BCA ASSESSMENT REPORT

**Flower Power Garden Centre
277 Mona Vale Road, Terrey Hills**

Revision 1

Date: 08 March 2022

Figure 2. Site Perimeter Vehicular Access per BCA C2.4

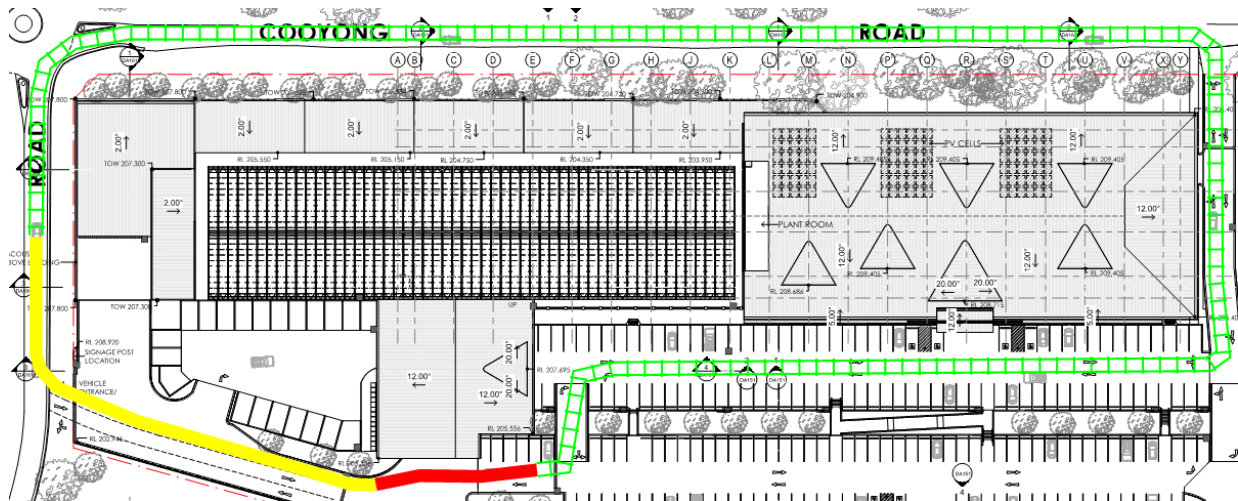
Comments: The proposed Northern Building does not fully comply with the provisions of C2.4 and thus the following non-compliance areas are identified on the site plan below. BM+G are of the understanding that these are proposed to be addressed via a Fire Engineered Performance Solution.

- A portion of the PVA is not within 18m of the building i.e. too far from the building (shown in **yellow** in the below figure),
- A portion of the PVA is closer than 6m of the building i.e. too close to the building (shown in **red** in the below figure),

Note: Perimeter Vehicular Access (PVA) is generally achieved around the building (shown in **green** in the below figure),

Note 1: Any proposed gates are to achieve no less than 6m unobstructed width or the reduced width will need to be included in the above Performance Solution.

Note 2: The driveways providing vehicular perimeter access must be designed with adequate loading capacities to withstand a fire truck and the gradients of any ramps and swept paths should take into consideration the requirements of the FRNSW Fire Safety Guideline – Access for Fire Brigade Vehicles and Firefighters.
